ADDENDUM 03

Roseville Joint Union High School District
West Park High School, Phase 2 – Increment 1
DSA Application Number: 02-118062

DLR Group Project No: 75-19101-00

15 A3.12 ROLLER SHADE RECESSED IN GYP. CLNG
SCALE: 3" = 1'-0"

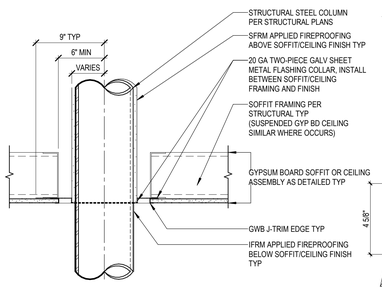
2. **Sheet A3.12 CEILING DETAILS**
   C. ADDED detail 15/ A3.12 – Roller shade recessed in gyp ceiling

1 **BLDG F SECOND FLOOR PLAN - MECHANICAL**
1/8" = 1'-0"

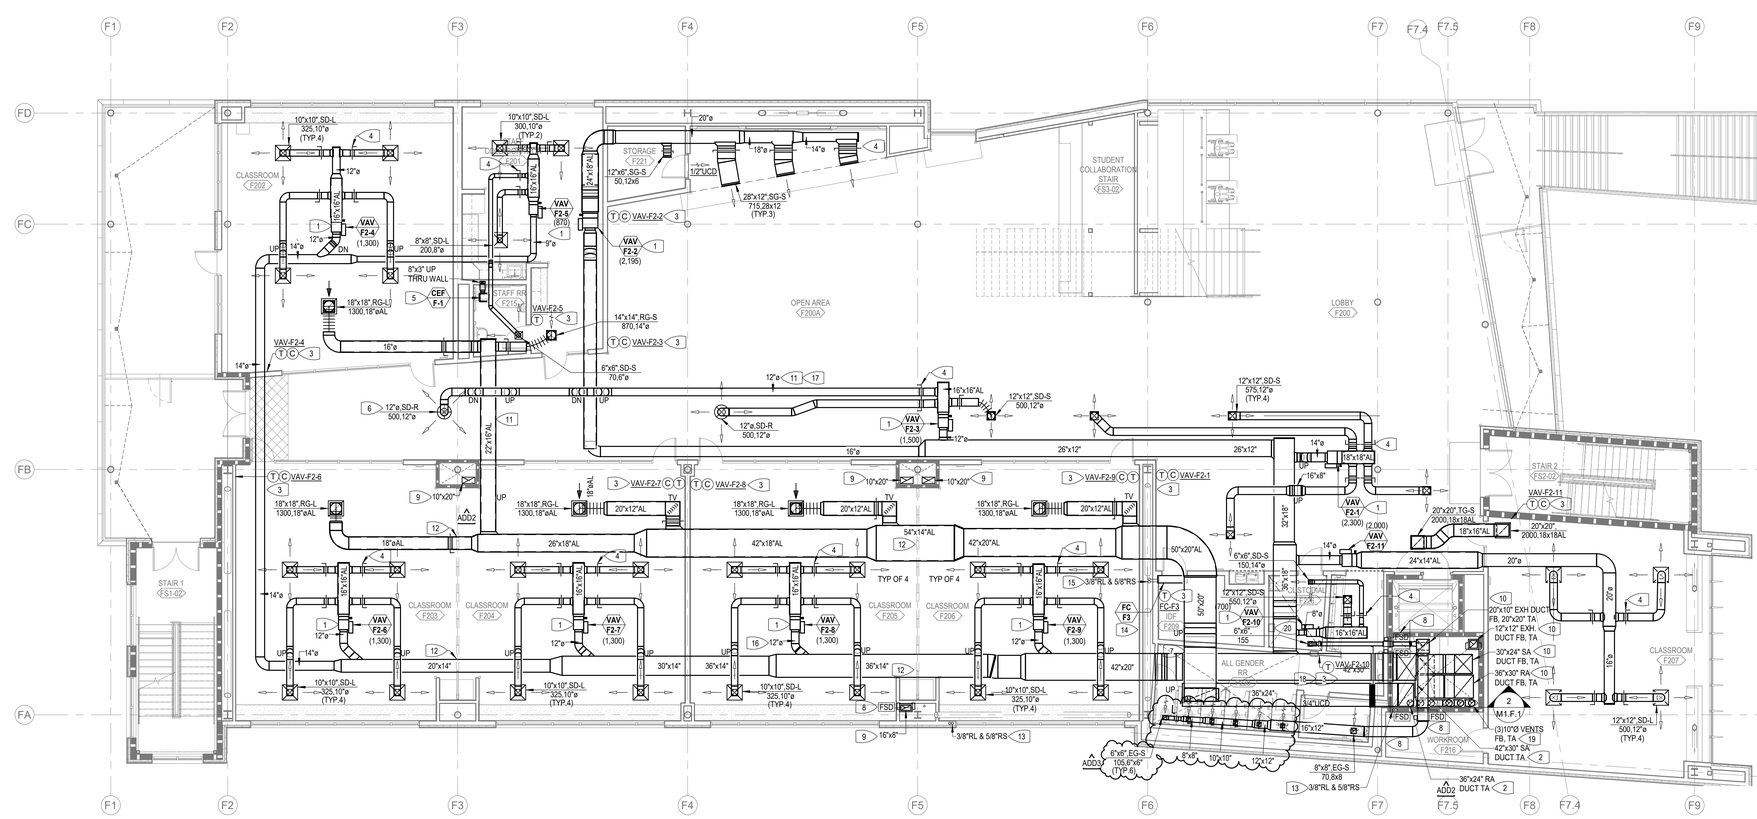
3. **Sheet M1.F.2 BLDG F SECOND FLOOR - MECHANICAL**
   D. REVISED ductwork and exhaust fans for full height partitions at All gender restroom.

1 **BLDG F THIRD FLOOR PLAN - MECHANICAL**
1/8" = 1'-0"

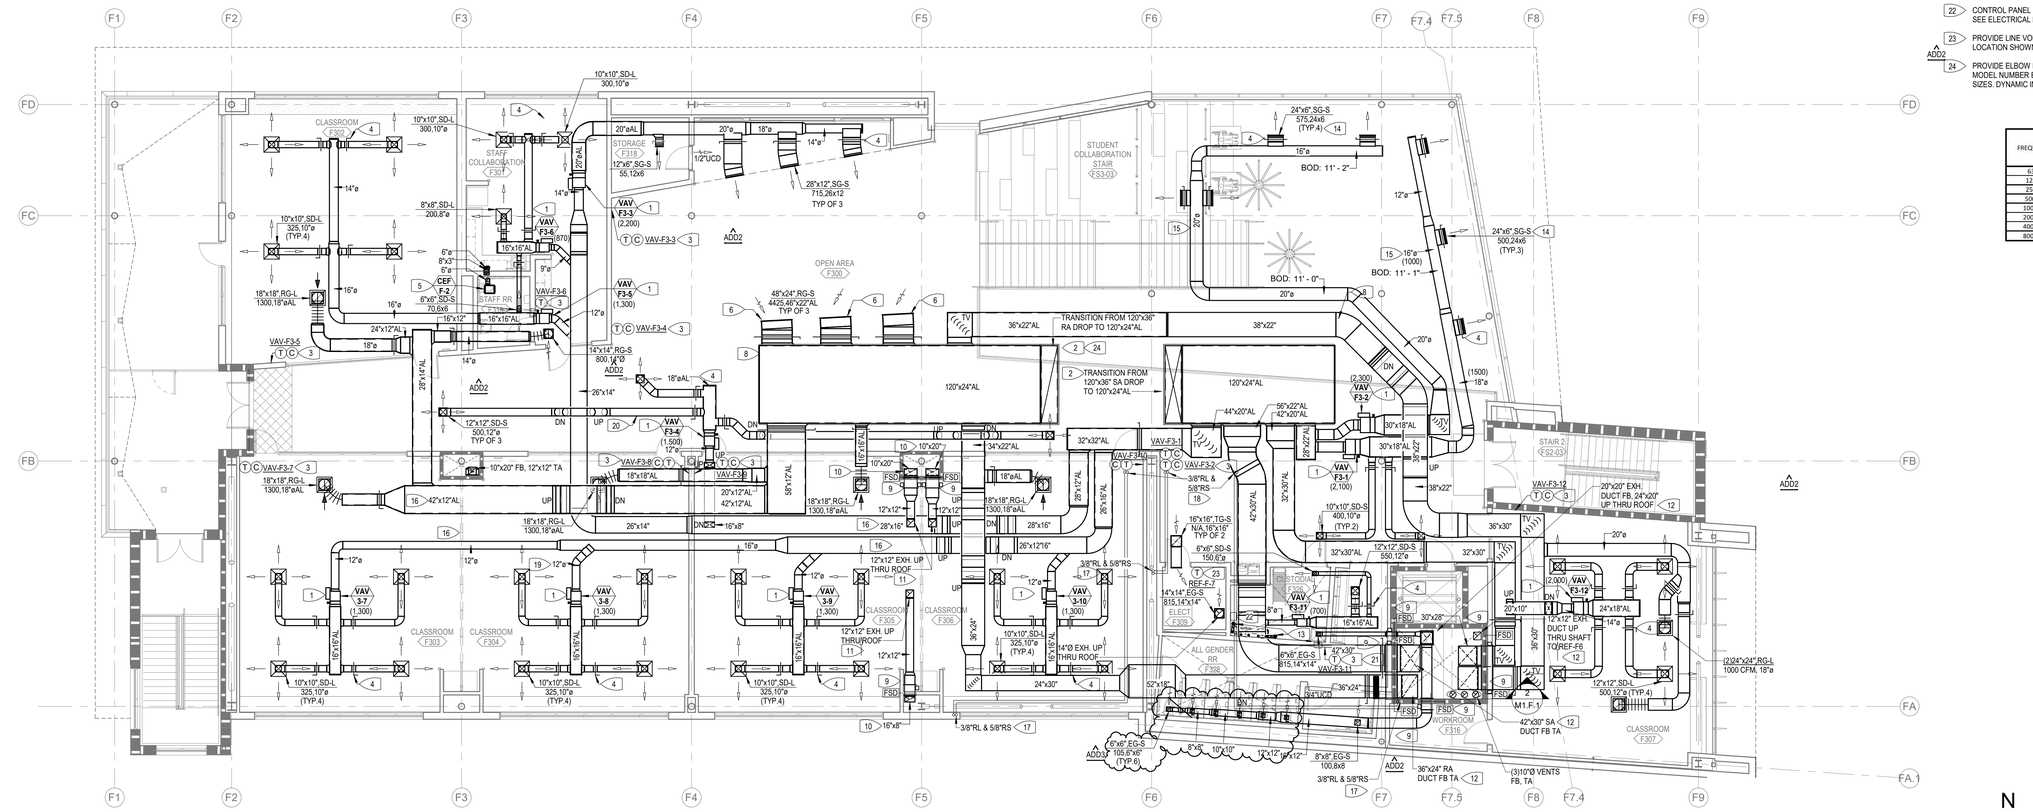
4. **Sheet M1.F.3 BLDG F THIRD FLOOR - MECHANICAL**
   A. REVISED ductwork and exhaust fans for full height partitions at All gender restroom.

1 **BLDG S SECOND FLOOR PLAN - MECHANICAL**
1/8" = 1'-0"

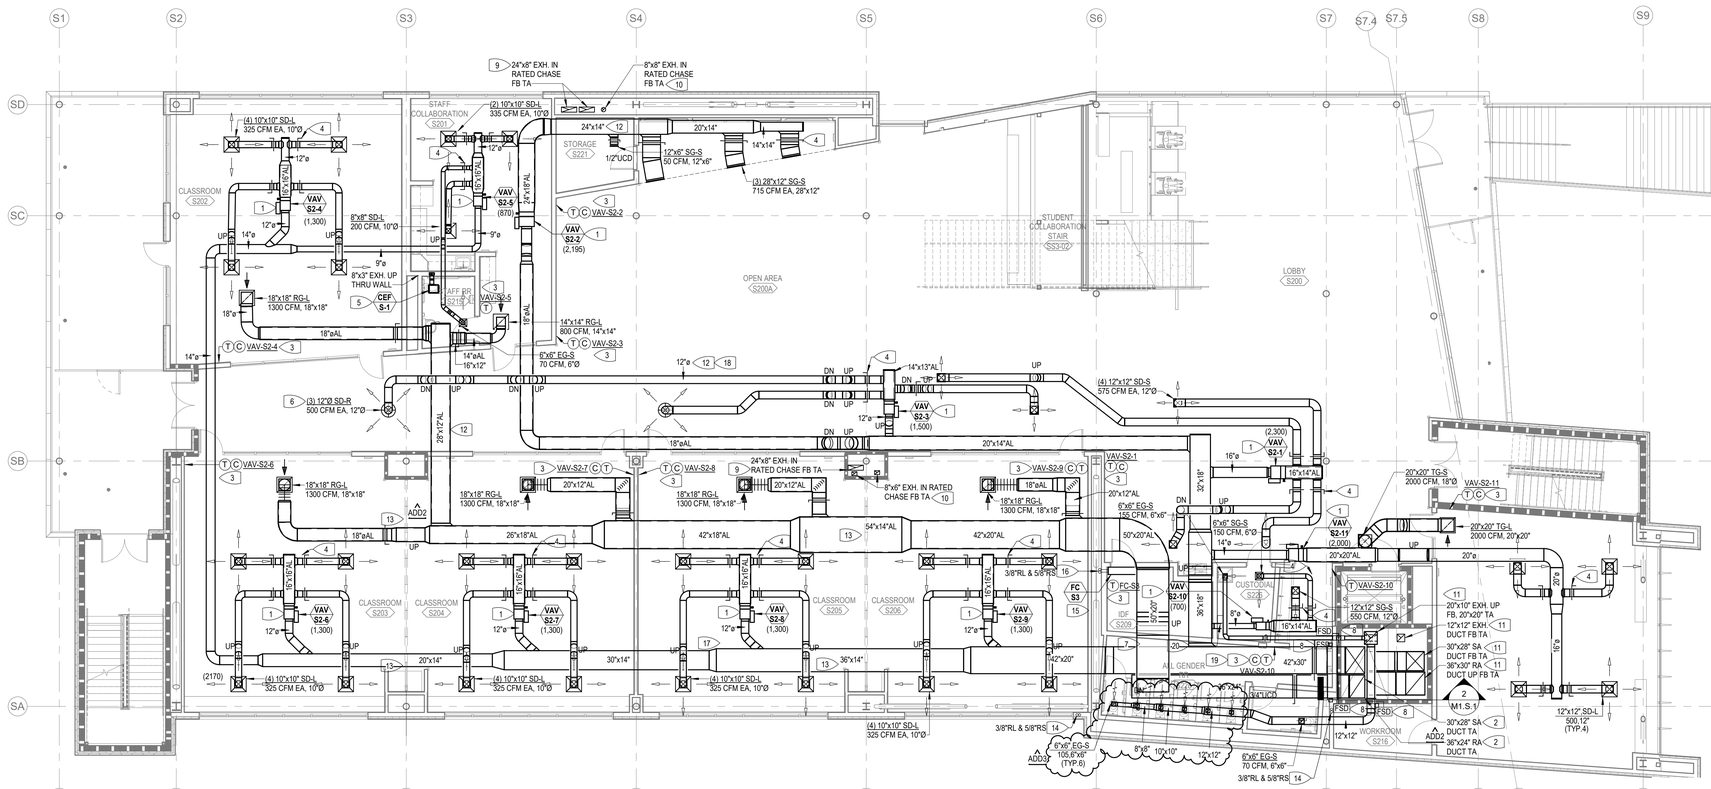
5. **Sheet M1.S.2 BLDG S SECOND FLOOR - MECHANICAL**
   A. REVISED ductwork and exhaust fans for full height partitions at All gender restroom.

1 **BLDG S THIRD FLOOR PLAN - MECHANICAL**
1/8" = 1'-0"

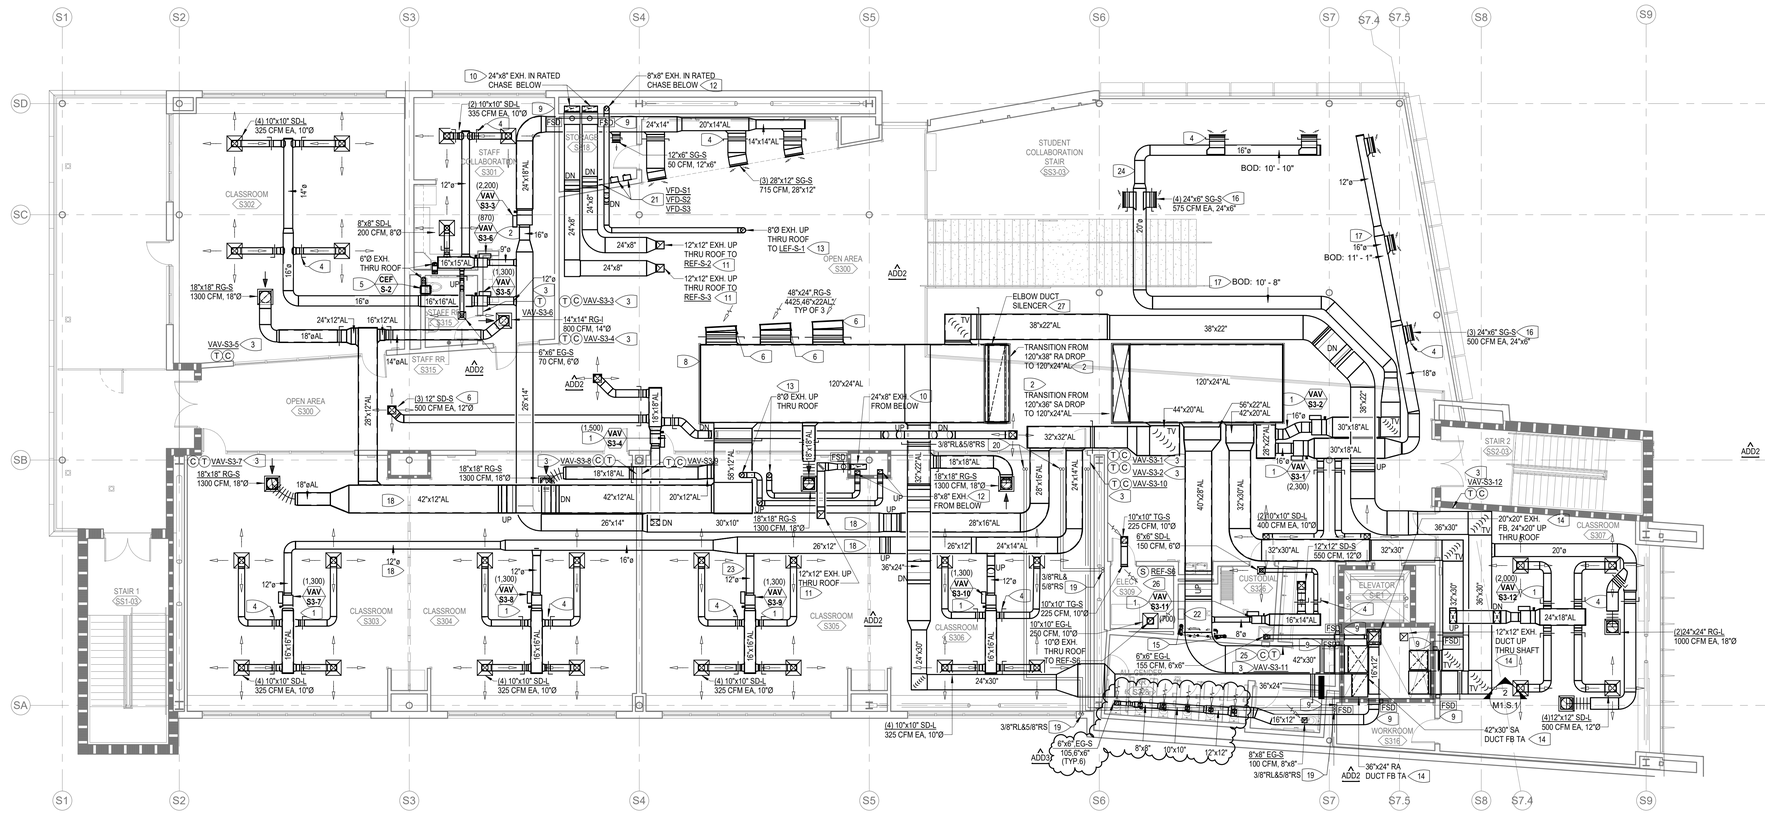
6. **Sheet M1.S.3 BLDG S THIRD FLOOR - MECHANICAL**
   A. REVISED ductwork and exhaust fans for full height partitions at All gender restroom.

FP1.F2.1

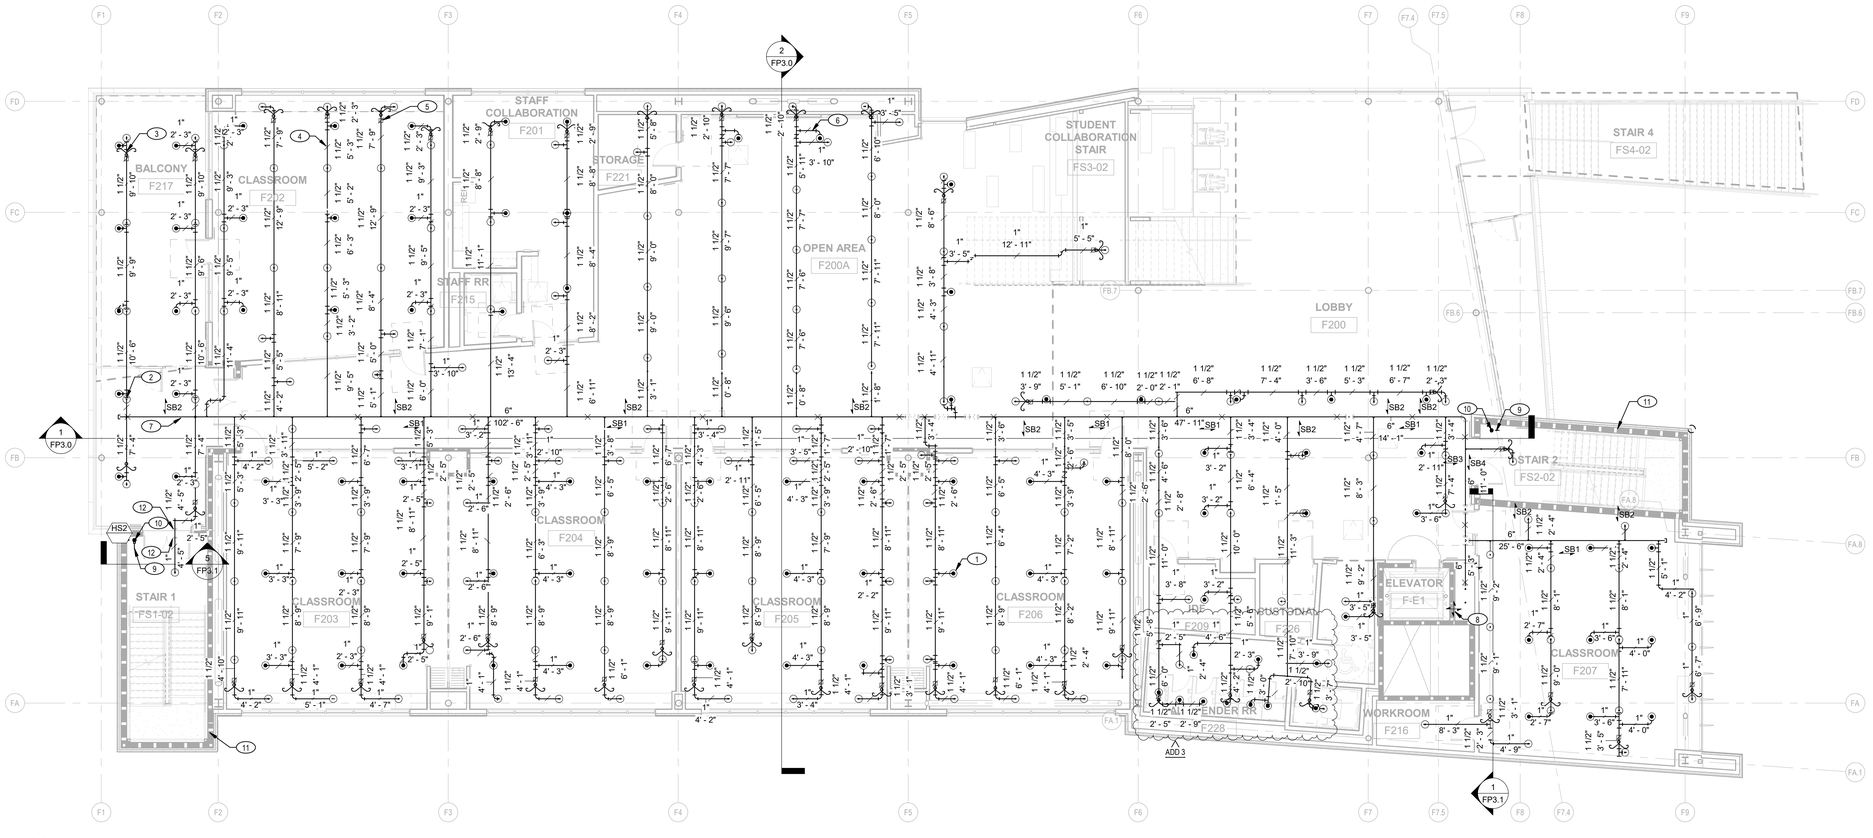
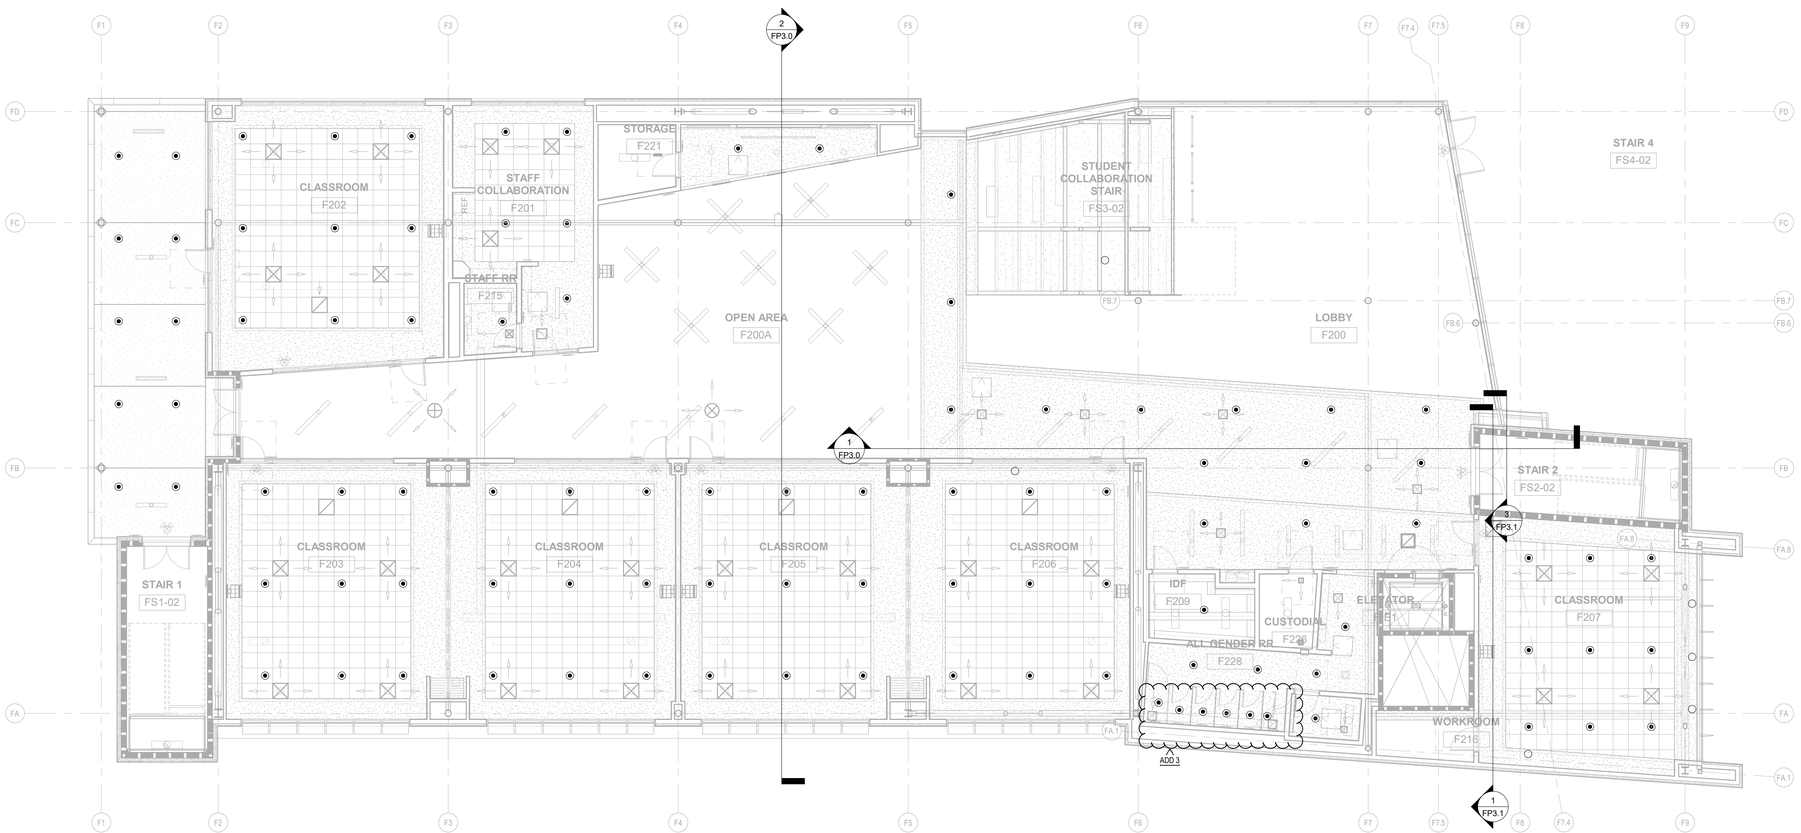
8. **Sheet FP1.F2.1 FIRE SPRINKLER – BLDG F – 2ND FLOOR**
   A. REVISED piping at All-gender restroom
   B. ADDED sprinkler heads to each stall at All gender restroom
